**DR98-120 PROPOSED WATERFRONT HOTEL**

**REQUEST:** Design Review of a proposed waterfront hotel

**NOTICE OF DECISIONS AND FINDINGS OF FACT FOR  
PROPERTY LOCATED AT Capitol Mall and Front Street  
SACRAMENTO, CALIFORNIA IN  
THE CENTRAL CITY CENTRAL BUSINESS DISTRICT  
DESIGN REVIEW AREA (DR98-120)**

THE DOCKS - CAPITOL MALL  
 SACRAMENTO, CALIFORNIA  
 ARCHITECTURAL ELEVATION  
 DRAWING NO. A-7  
 DATE: 03/17/99

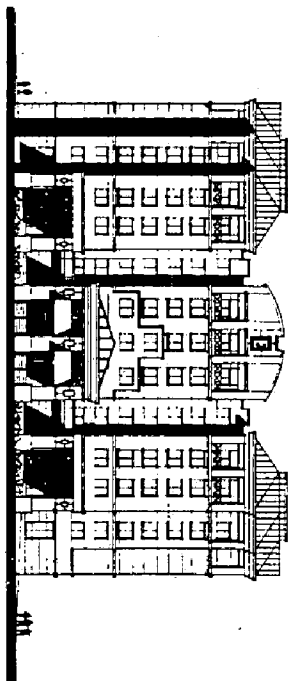
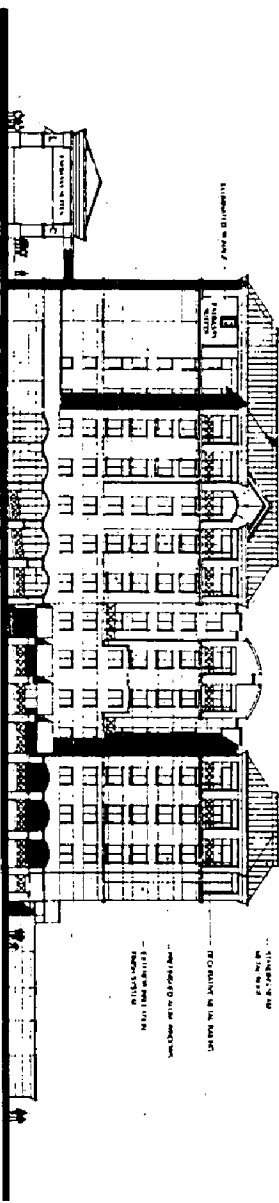
1. Look at blank walls, add detail or windows, especially those facing the Crocker Art Museum.
2. Add roof line to the se corner of the building.
3. Add more color to the bldg, explore using different colors.
4. Look at adding railing to all the windows.

1. Need more interesting features on the east side.
2. Building looks to sterile, needs more detail, railings, etc.
3. Needs more design enhancements.
4. This site is important, need to have a good design.

- Steven G.: There are blank walls on the design that should be fenestrated.
- Steade C.: Can't granite be used at the base? The project should have the best materials within your budget.
- Bob Mc.: I like this version much better.
- Steade C.: I suggest reducing the portecochere and the primary facade match setbacks of other buildings on Capitol Mall.
- Steven G.: I disagree, I think the setbacks on Capitol Mall are meaningless.
- Steade C.: Keep portecochere simple, more use of glass. Lower the darker color to create more of a base and better articulate the elevations.

- Steven G.: 2" of difference in the wall plane is not very substantial, so it is better to play down the darker color.
- Steades C.: Recess the windows in 2 or 3 more inches to give more shadow line to the facade. I like the dormers breaking up the horizontal lines of the building.

12. The massing of the project shall be broken up with the use of both vertical and horizontal planar changes and building step backs as proposed in the elevations reviewed by the Board. Decorative metal balconies shall be used at the upper windows to add further depth to the facade. The roof line shall be broken up by utilizing a combination of roofed areas and parapet walls as indicated in the elevations reviewed by the Board.

13. The building windows shall be inset 4 to 6 inches from the main wall plane to provide a shadow line and further enhance the facade. A decorative projecting sill shall be provided for the windows. The windows shall be as proposed, including: storefront style mullions at the lower windows at the portecochere area, arched windows at the first floor of the west elevation facing the river, inset windows with sill treatment at the building shaft, and windows accented with balconies at the upper level. Final window details, color, and design shall be reviewed and approved by staff.

EAST ELEVATION  
SCALE 1/8" = 1'-0"

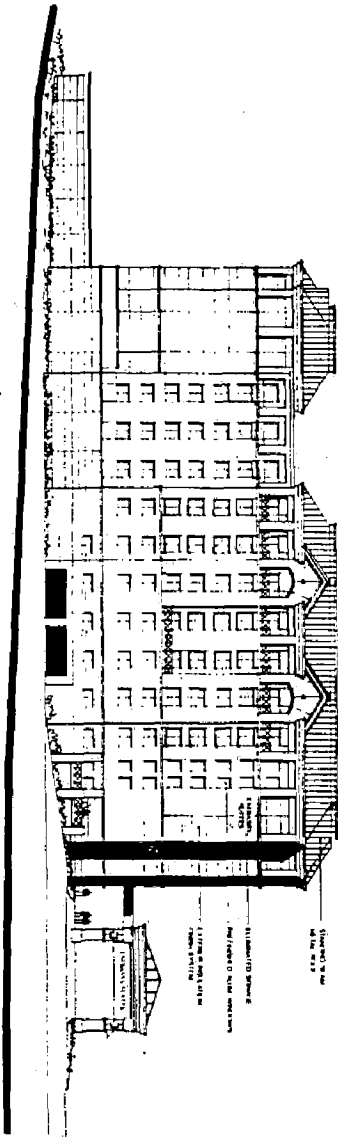
1. Provide a stronger sense of entry.
2. Do not add more balconies, they would appear "pasted on".
3. Add windows on some of the blank walls, but allow the wall facing east to remain as proposed, simply adding greater definition at the top, with a cornice treatment.
4. The roof should be a high quality metal roof, with a "batten" design.
5. Lower the color line as proposed by the architect.
6. Provide additional detailing at the windows, better define the sill piece.
7. Acknowledge the budgetary issues related to achieving the best design.
8. Precast panels at the portecochere and restaurant outdoor area should have a "honed" finish, not highly polished, preferably.
